Subject: Zoning By-law Amendment – 1081 Carling Avenue

File Number: ACS2023-PRE-PS-0118

Report to Planning and Housing Committee on 20 September 2023

Document 5 – Consultation Details

Building Elevation – West Tower (West Elevation)

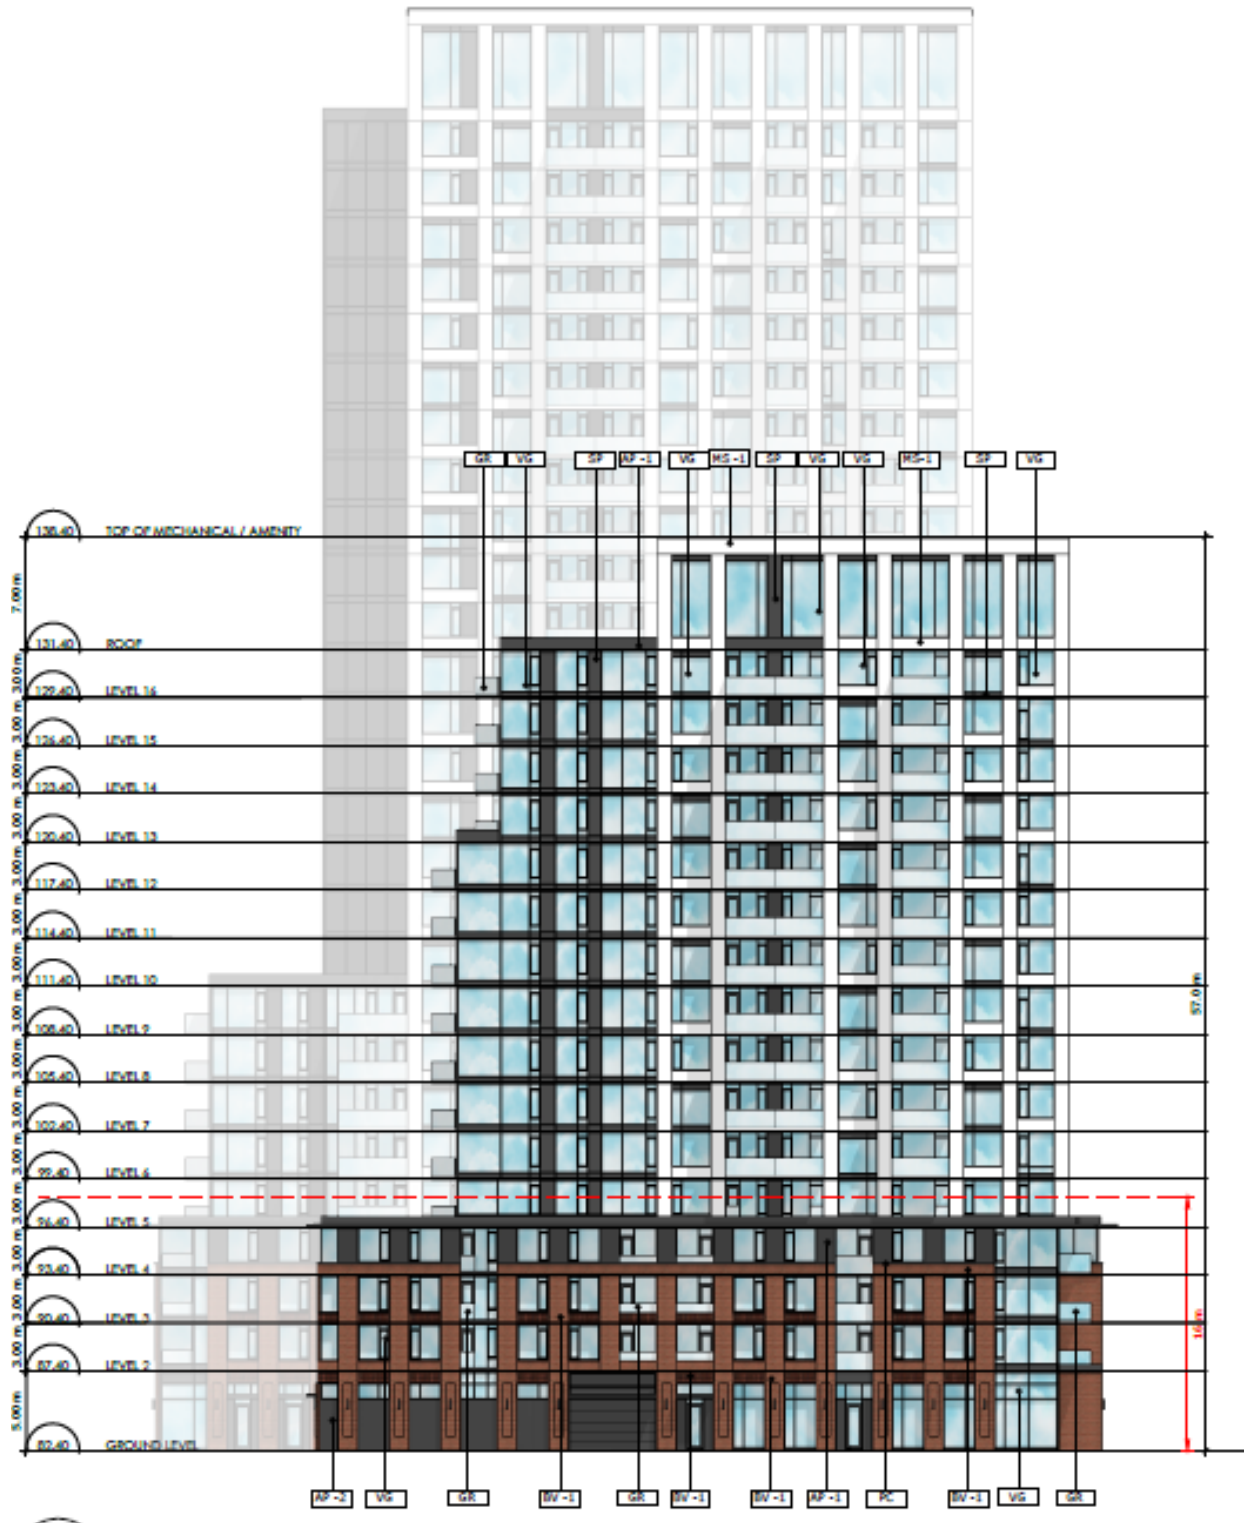
- Concerns that the West Tower fails to achieve the minimum 20-metre setback from the closest residential property (425 Hamilton Avenue South).
- Concerns that the proposed development does not meet the 45-degree angular plane. A more gradual transition should be provided.

- There are several ways to improve the transition between the Eastern Tower and the adjacent low-rise neighbourhood:
 - Increase the step-back between the low-rise and mid-rise portion of the building. The current step-back is approximately 3 metre. A larger step-back, in the 6 to 9 metre range, would improve transition. It should be noted that the step-back is 8.5 metres on the Western Tower, AND
 - A reduction in height to either bring the building into conformity with the 45 degree angular plane or bring it much closer to conformity with this angular plane. The Addendum did not include any modeling with respect to the 45

The Official Plan identifies that the subject site to be appropriate for high-rise development (10 to 40 storeys) subject to appropriate height transitions, stepbacks, and angular planes. Staff are satisfied that appropriate transition has been achieved for both towers through the utilization of a gradual change in height and a minimum 20-metre setback from the tower portions of the buildings to the low-rise neighbourhood to the north.

Staff are satisfied that the criteria identified in Policy 2 of Section 5.2.3 of the Official Plan are met, which provides direction regarding permitted building heights along Mainstreet Corridors within the Inner Urban Transect. It is acknowledged that the policy identifies that building heights up to high-rise (10-40 storeys) are permitted along segments of streets whose right-of-way (after widening requirements have been exercised) is 30 metres or greater as identified in Schedule C16, subject to appropriate height transitions, stepbacks, and angular planes. However, staff disagree with the interpretation of “angular plane” outlined in the above comments. Staff interpret the angular plane to be a guide/tool for achieving appropriate transition, as directed in the Urban Design Guidelines for High-rise Buildings, rather than being a prescriptive requirement. Further, the figures included in Section 4.6.6 are included for information purposes, and are not considered policy, as outlined in Section 1.4, How to use the Official Plan. Therefore, a proposed development where the entire mass of a building does not fit within the 45 degree angular plane can still achieve appropriate transition and be considered to conform to the policies of the Official Plan, where the proposed massing, height transitions, and stepbacks are generally guided by the application of an angular plane.

Building Elevation – East Tower (West Elevation)

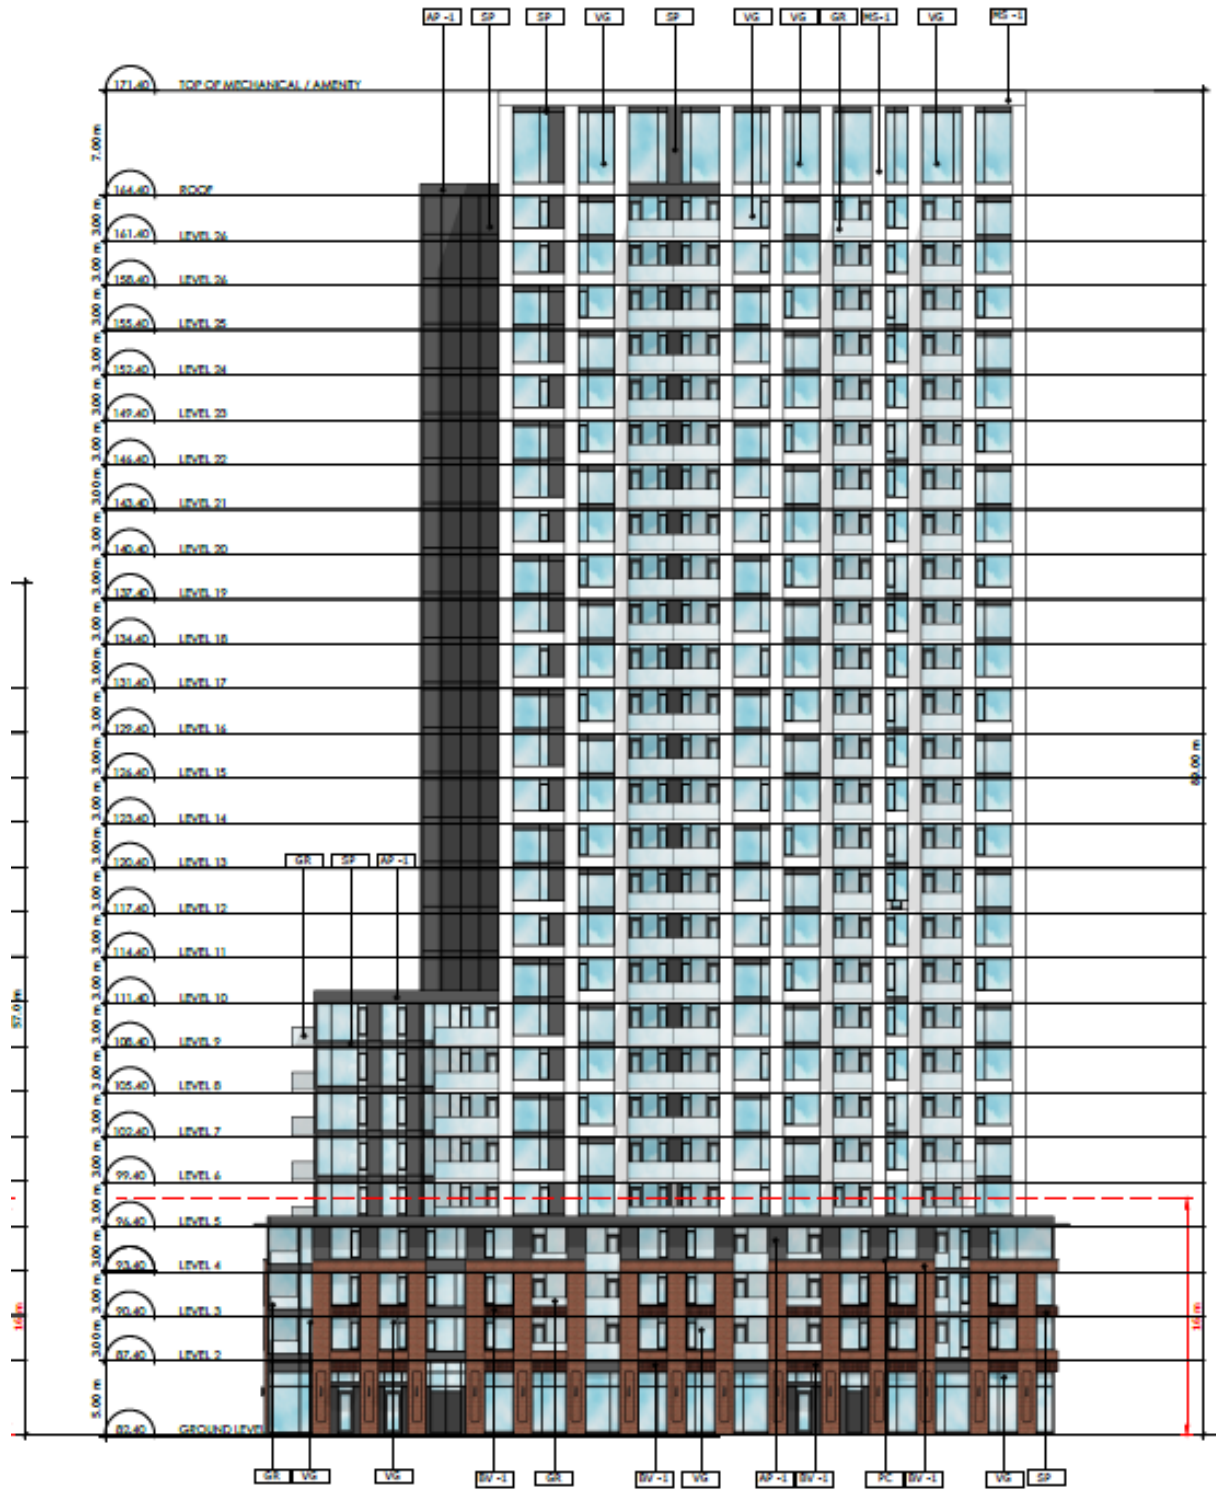
- Concerns that the 27-storey height does not fall within the 45-degree angular plane, as required by section 4.6.6 of the New Official Plan and as shown in Figure 15 of the New Official Plan.
- Concerns that the 27-storey height does not meet the criteria and test found in Section 5.2.3(2) of the Official Plan. Specifically, the Policy states:

It is submitted that the 27 storeys proposed for the Subject Property does not meet policy 5.2.3(2) and (2) (ii) because the property does not conform to the 45 degree angular plane (required by policy 4.6.6 and explained further by Figure 15 contained in this policy) nor does it provide an adequate height transition. Further, it is submitted that a 27 storey building (and also a 25 storey building

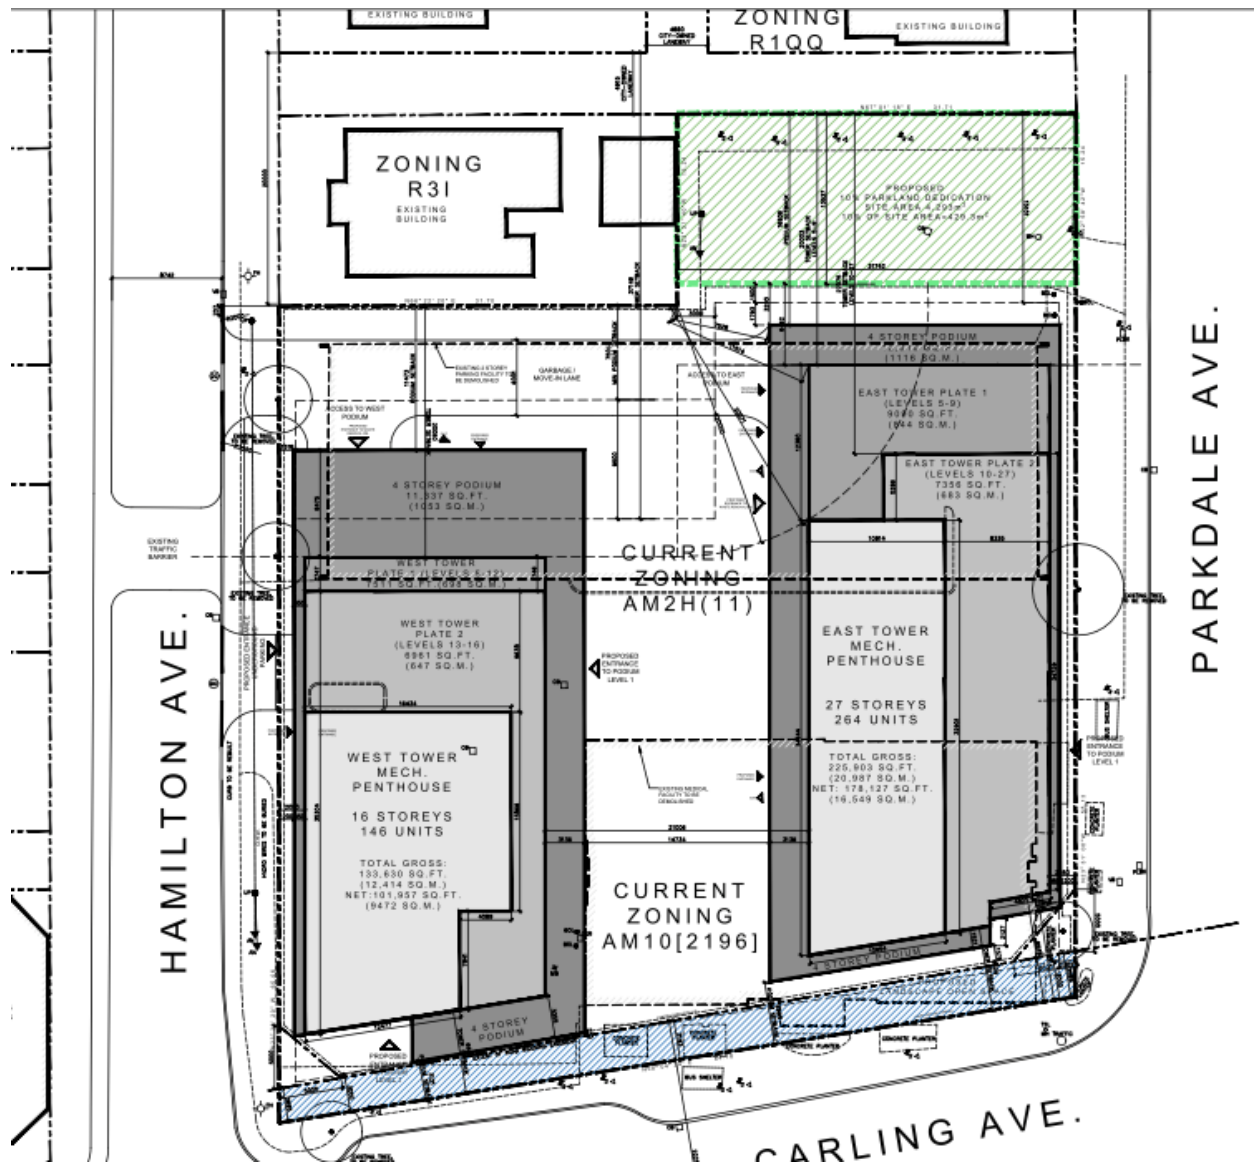
this is that they provide an appropriate transition to the adjacent low-rise neighbourhood. If one follows the letter of the OP, reading each word with its plain-language meaning, the logical conclusion is that developments like these must provide a 45-degree “angular plane” from adjacent properties. I won’t delve far into it, but it means essentially that from the property line the height of the development can’t rise at an angle steeper than 45 degrees, and that setbacks have to be introduced that constrain the height along that slope line. No one disagrees that the east tower fails utterly to achieve a 45-degree angular plane. The west tower is very close, but also fails to achieve it.

I begrudgingly believe that that transition is achieved. Where the west tower achieves something close to a 45-degree angular plane with what is considered a relatively generous setback to the property line abutting the neighbour’s property to the south, the east tower cannot be said to achieve the required transition through stepped height reductions.

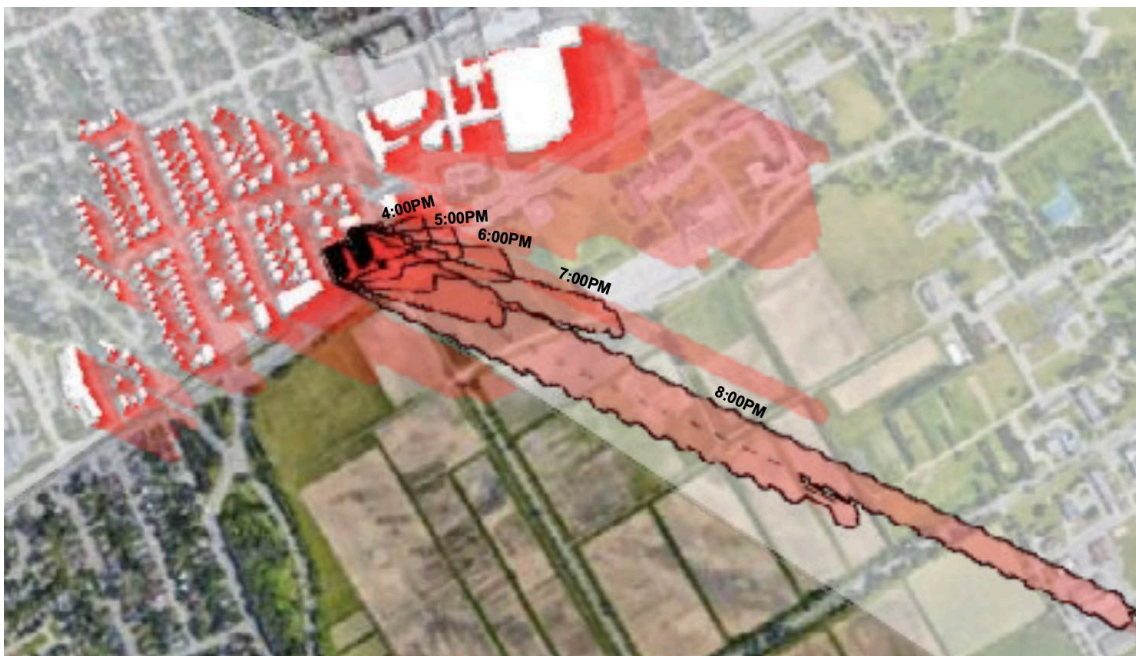
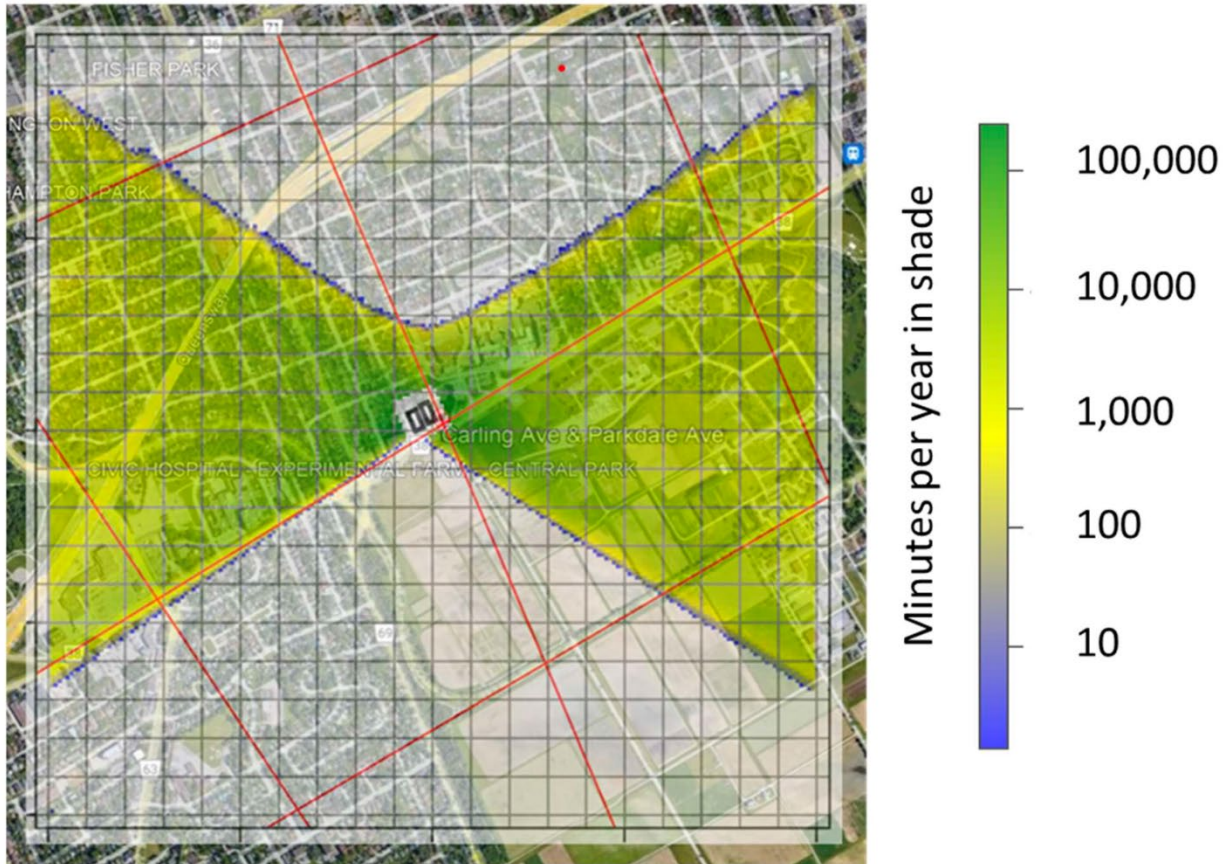
I’ve shown here a detail from the proposed site plan. The configuration would see, from the north, the nearest R1QQ property, a 4.9 metre-wide City-owned laneway, a 13.5 metre-deep parkland dedication and a 3.3 metres-deep setback from the podium to the boundary with the park. In all, there is a roughly 21.7 metre setback from the southern edge of the adjacent low-rise to the east tower’s podium. This is, by any measure, a

The problem arises as the tower is stepped back just 3.2 metres from the podium for levels 5-9 before levels 10-27 rise up without stepback, albeit with a reasonably generous 7 metres stepback from the levels below it.

An appropriate transition to the east tower in terms accomplished by distance is, by today's standards, arguably in place. The challenge is that despite the generous distance that tower just rises up without break to a height that doesn't meet an angular plane. On balance, I'm comfortable that if the Official Plan test is that there be an appropriate transition accomplished by various means that this is demonstrable in this proposal. Few people really like height, but it is set back to a degree that Council has
